**MAJOR SITE DEVELOPMENT PLAN**

**7-ELEVEN**

**DEVELOPMENT PLAN  
7-ELEVEN  
COVER SHEET**  
LOT 1 ACADEMY GATEWAY SUBDIVISION FILING NO. 1

# Markup Summary

DEVELOPMENT PLAN  
**7-ELEVEN**  
 SITE PLAN

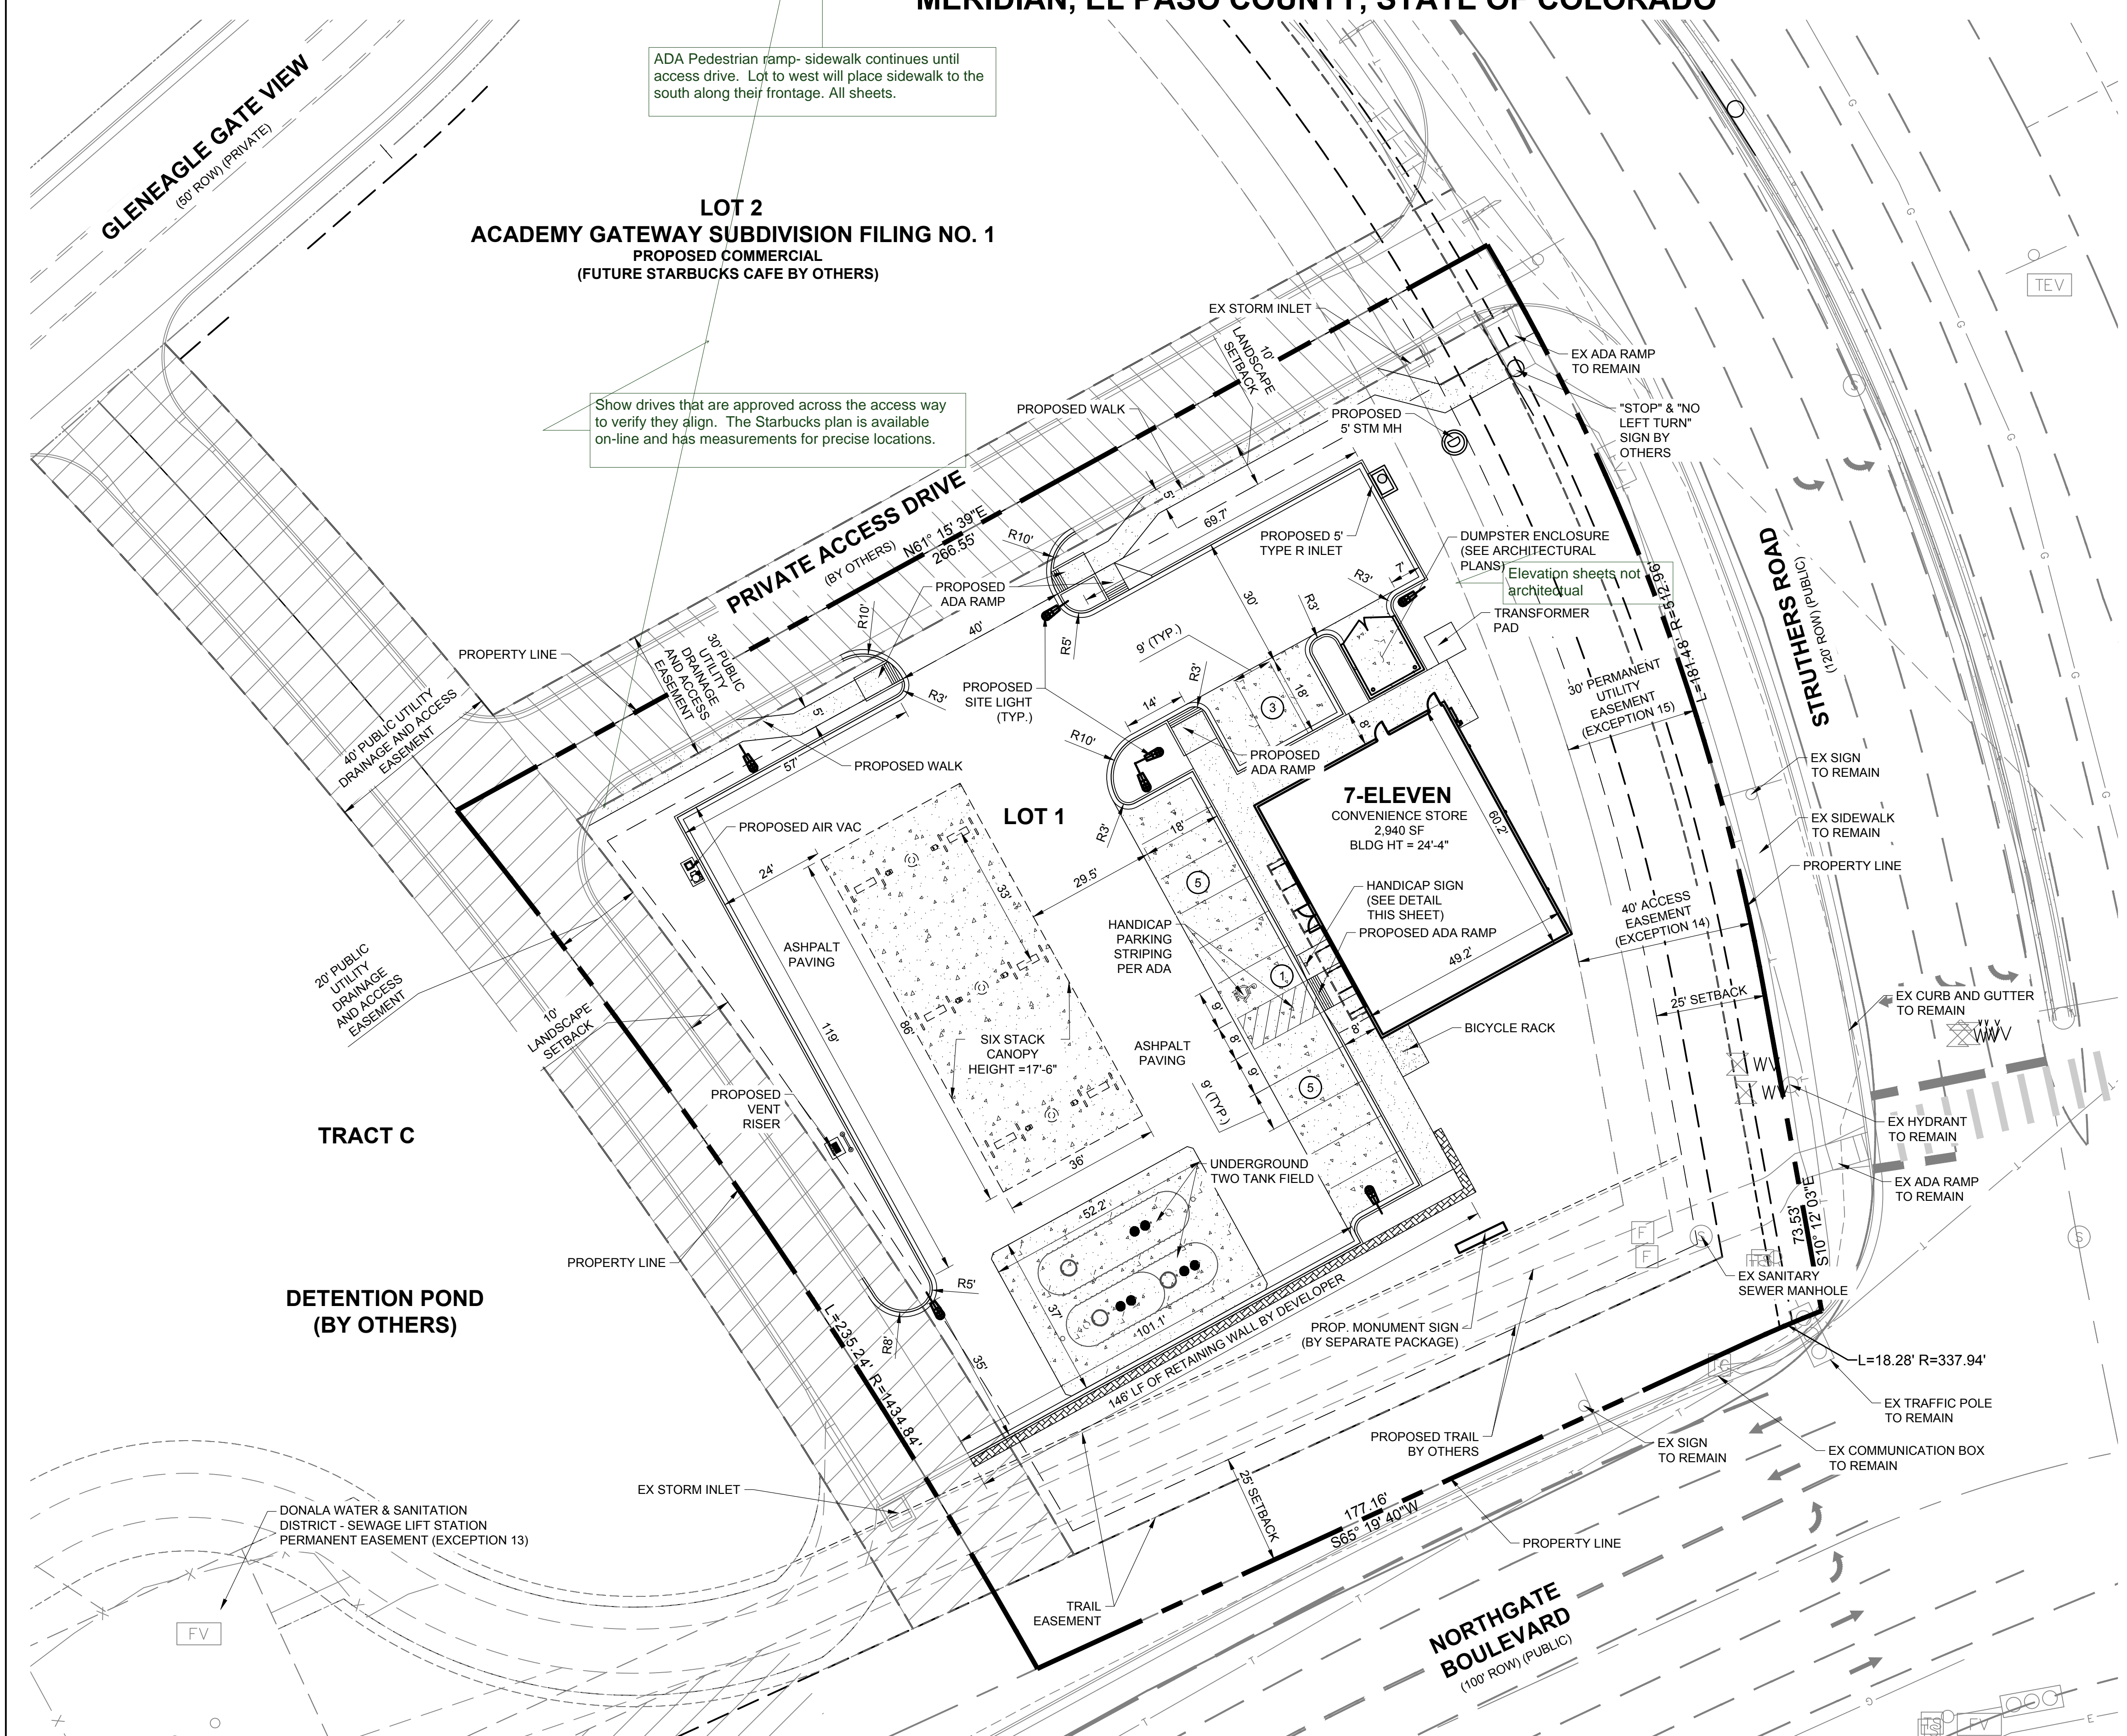
ADA Pedestrian ramp- sidewalk continues until access drive. Lot to west will place sidewalk to the south along their frontage. All sheets.

Show drives that are approved across the access way to verify they align. The Starbucks plan is available on-line and has measurements for precise locations.
